Re: Variation of condition two associated with application 2023/62/91345/E for the erection of a single storey building with roof top plant area to provide outpatient theatres, treatment rooms and consultant rooms with link to Boothroyd building, including demolition and remodelling of existing ramp and associated landscaping and drainage.

Berrys have been assisting Darwin Group to address several amendments that are now required for the new NHS facility at Dewsbury District Hospital, Halifax Road, Dewsbury, WF13 4HS. These proposed amendments are due to further detailed design stages and updated safety requirements.

This s73 application is therefore seeking to vary Condition 2 of the planning permission ref: 2023/62/91345/E.

Proposed (Eastern elevation)

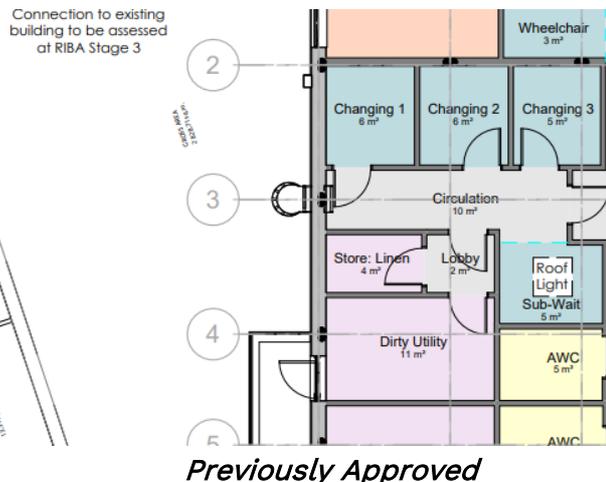
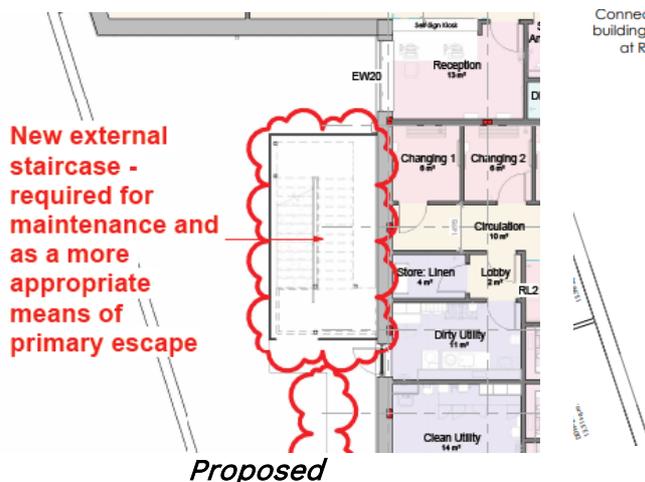
The CAT ladder on the south elevation has been relocated to improve the functionality, safety and visual appearance of the building. The main reason behind the relocation is due to the fire strategy and safety requirements. The escape distances for a secondary means of escape must comply with building regulations. Therefore, the applicant has had to relocate the ladder following the approval of an unsuitable original design.

In addition, the CAT ladder was originally located on a pedestrian route in a visibly prominent location. The proposed new location will have greater safety and visual

benefits as it is located within an enclosed and secure area. This will reduce unauthorised access which, in turn, further improves the site safety.

Proposed

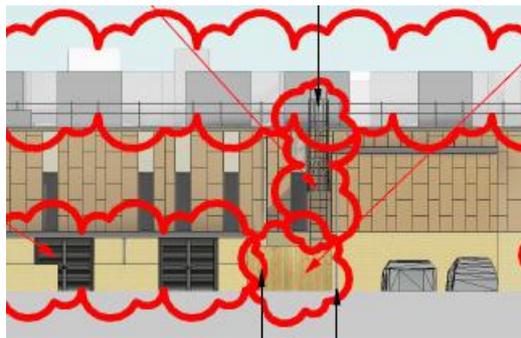
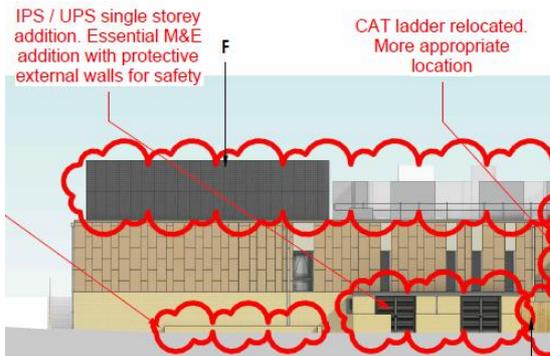
The proposed relocation of the CAT ladder between the IPS/UPS rooms and the lift was reconsidered due to significant safety and security risks, including the potential for unauthorised roof access. In accordance with fire safety protocols, the CAT ladder is now designated solely as a secondary emergency escape route, not for routine access.

Primary roof access is now provided by the external staircase, offering a safer and more controlled entry point for maintenance. To secure the CAT ladder, a vertical close-boarded timber fence with a lockable gate was installed around the area, limiting access to authorised personnel. This enclosed space also houses condenser pumps, providing a secure and compliant location for essential air conditioning equipment. As the building will be used by the public, having enclosed and controlled access is a key safety feature for the building.

Addition of mini plinth wall (Eastern Elevation)

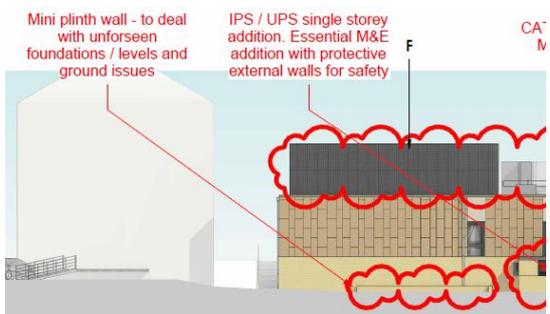
The south-east corner of the building, located at the site's lowest point and densely packed with essential infrastructure, presented spatial and level-related challenges. During landscaping works, sections of critical structural foundations were exposed. As altering these was not an option, a low plinth wall was introduced to conceal and protect them. This solution maintained the building's structural integrity while supporting the intended landscape design and pedestrian pathway. It also enabled the creation of a DDA-compliant accessible route, effectively balancing structural protection, visual coherence, and accessibility requirements. The building will be used by patients who may have mobility issues or require walking aids therefore, having a DDA compliant access with no exposed sections is a beneficial amendment to the building.

External Door removed from Western Elevation

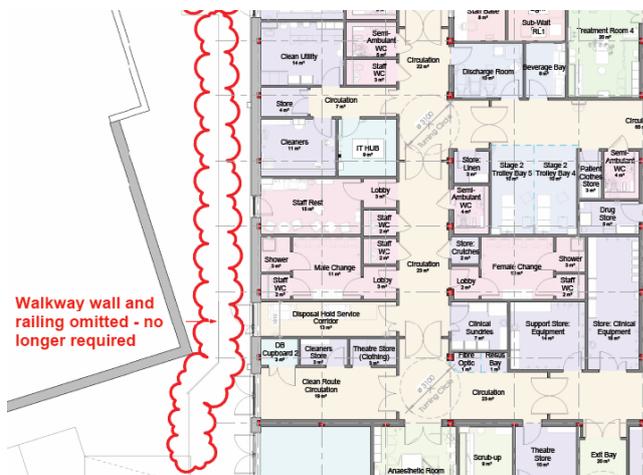
The original design featured two separate plant rooms—one requiring dual escape routes and the other needing only single access. However, as the mechanical and electrical layout was refined, it became clear that a single, larger plant room would be more efficient. The internal partition is therefore proposed to be removed, merging the two rooms into one.

This combined space initially included three external doors, exceeding escape and access requirements. With services now aligned along the perimeter wall, the southernmost door on the west elevation was no longer needed. Its removal will improve the building's appearance without compromising safety, functionality, or compliance with Approved Document B of the Building Regulations.

Proposed

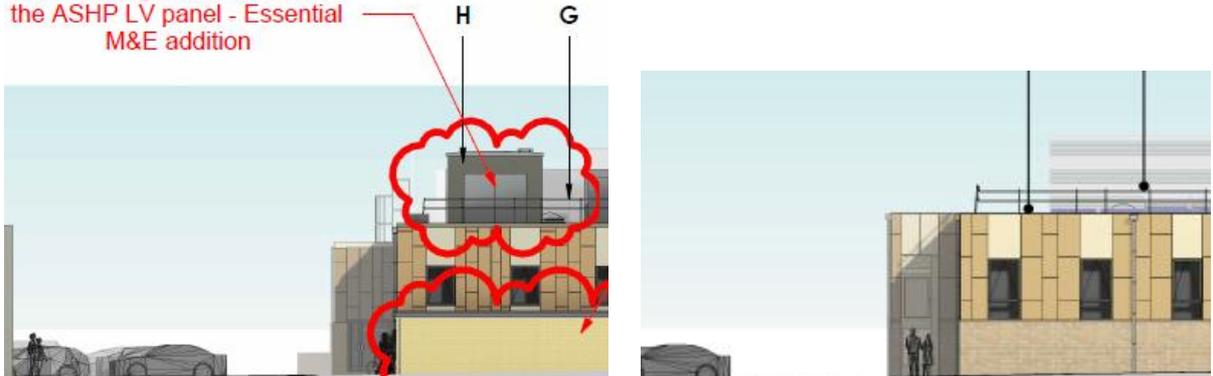
During the transition from RIBA Stage 3 to Stage 4, the original M&E design was found to be inadequate, as the detailed performance requirements revealed a greater need for rooftop plant than initially anticipated. Additional roof plant is required to help provide essential services to the hospital building. Without the proposed plant, the building would have a reduced function which will in turn, limit the value and service of the healthcare facility. To meet the buildings demands, the proposed changes were made to the rooftop M&E layout. These are considered to be essential to the building's operation.

To reduce visual impact, plant was carefully positioned, screened, and kept to the smallest practical footprint. These adjustments were key to achieving the building's BREEAM Excellent rating, which required enhanced sustainability and energy systems—many dependent on rooftop installations. With no viable alternatives for location or massing, the final design reflects a carefully considered balance between technical necessity and the visual impact.

GRP housing added to enclose the ASHP LV panel - Essential M&E addition

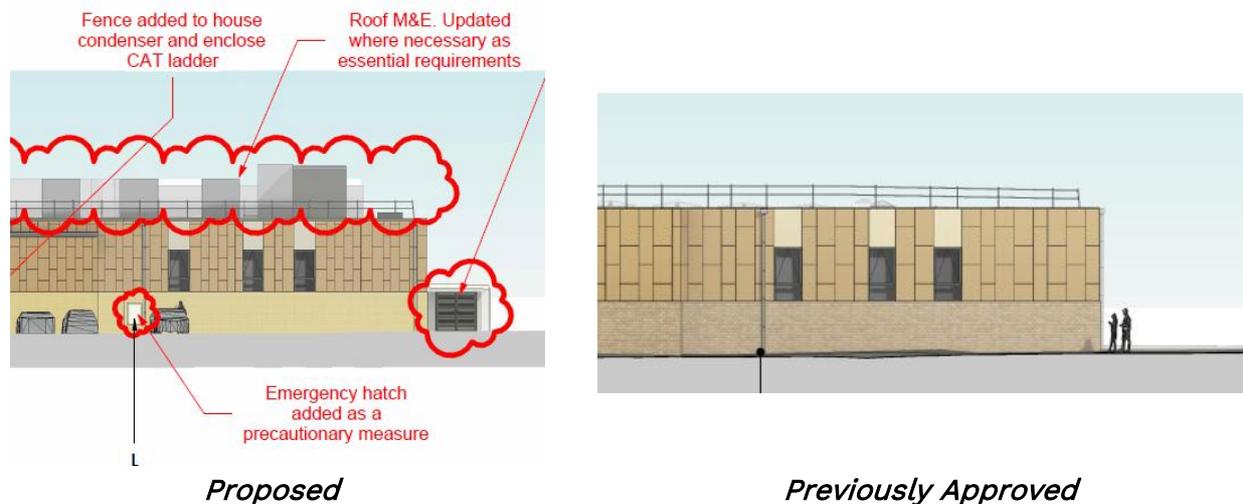
The GRP housing, like the LV and IPS/UPS rooms, protects a vital part of the building's power infrastructure—specifically the LV panel serving the rooftop Air Source Heat Pumps (ASHPs). To ensure efficient operation and compliance with BS EN 61439, the panel is located close to the ASHP units.

The GRP enclosure meets all regulatory size requirements while minimising visual impact. It is finished in a grey tone to match the existing rooftop plant, allowing it to blend discreetly into its surroundings. This carefully considered design ensures that the enclosure remains visually unobtrusive and in keeping with the building's overall aesthetic and context.
